Informational Bulletin No. CO20061218
Subject: Pump Casing Cracking
Model: QP4TH
Product Group: Trash Pumps
Date: 02/01/2007

Machines Affected:
QP-4TH S/N 4TH-0653 AND BELOW

Figure 1. Impeller/Seal Washer Installation

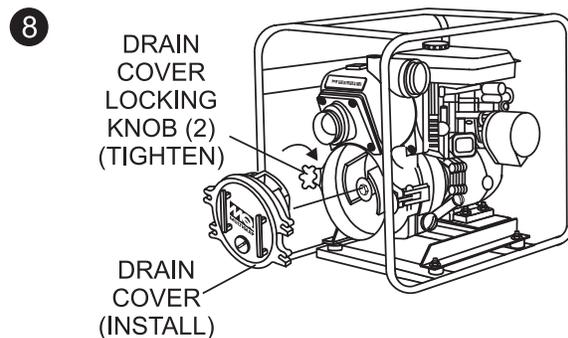
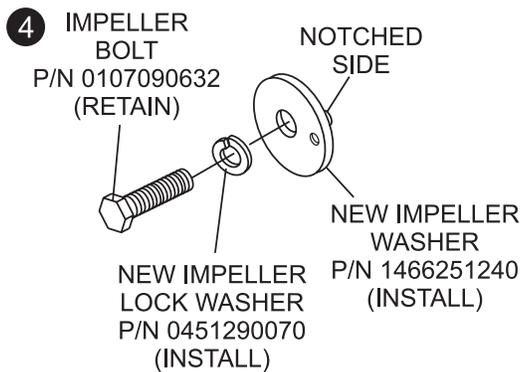
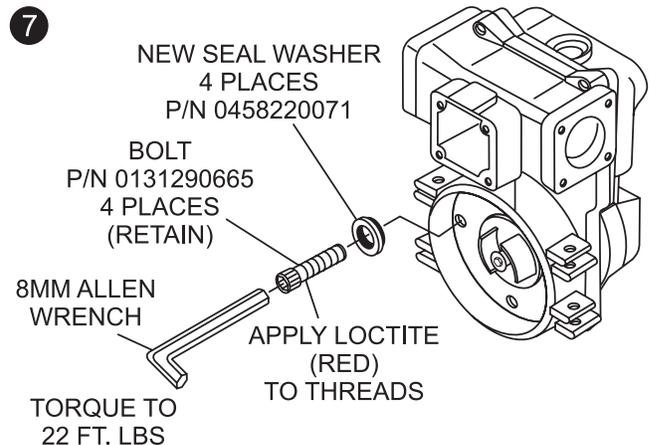
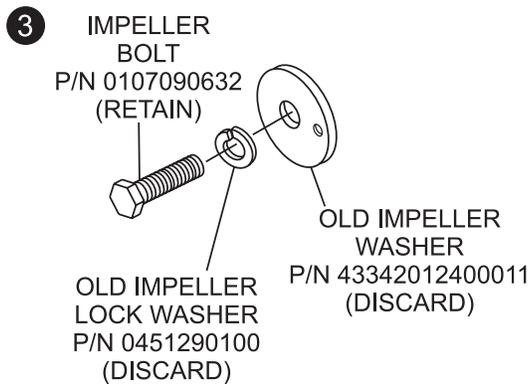
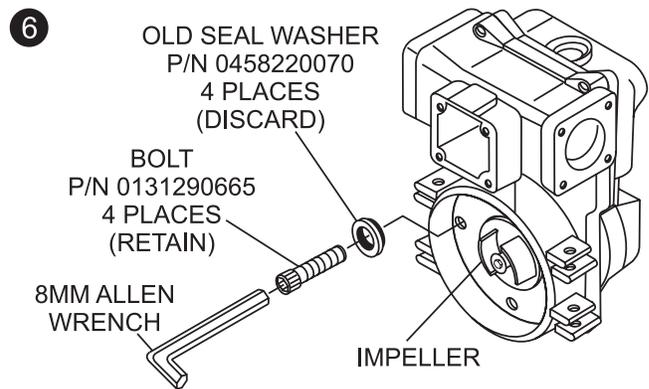
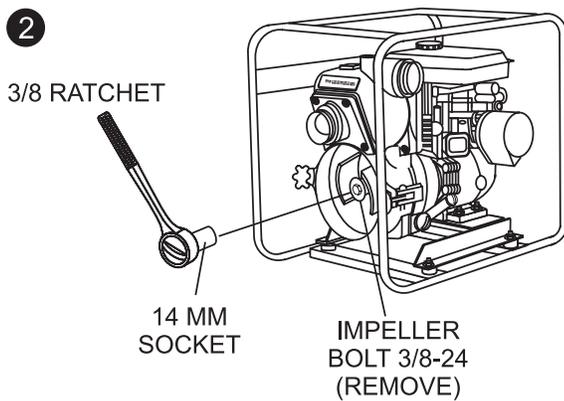
- Pump casings are cracking due to loose fitting impeller washers (2).
- Casing cover seal washer has thick rubber causing the casing cover to become loose.

- Replace impeller washers with new style washers.
- Replace seal washer with new style washer and apply Loctite (P/N 60098) when casing cover is set to mounting flange of engine.

4. Install the new impeller lock washer (P/N 0451290070) onto the bolt as shown in Figure 1. Next, place the impeller washer (P/N 1466251240) with the key side (raised notch) facing outward onto the impeller bolt.

5. Insert impeller bolt along with associated hardware (Step 4) into engine shaft. Be sure to align the notch on the impeller washer with the key way on the engine shaft. This will lock the impeller washer in place. Tighten impeller bolt to 22 FT-LBS.

6. Remove the 4 bolts (P/N 0131290665) from the inside of the casing cover with an Allen wrench and set aside. Remove and discard the seal washer (P/N 0458220070). Replace the seal washer with the new one (P/N 0458220071).

7. Reinstall the 4 bolts (P/N 0131290665) removed in step 7 and apply Loctite to the threads. Tighten bolts with an Allen wrench to 22 FT-LBS.
8. Reinstall drain cover back into pump casing. Turn locking knobs clockwise to secure drain cover.
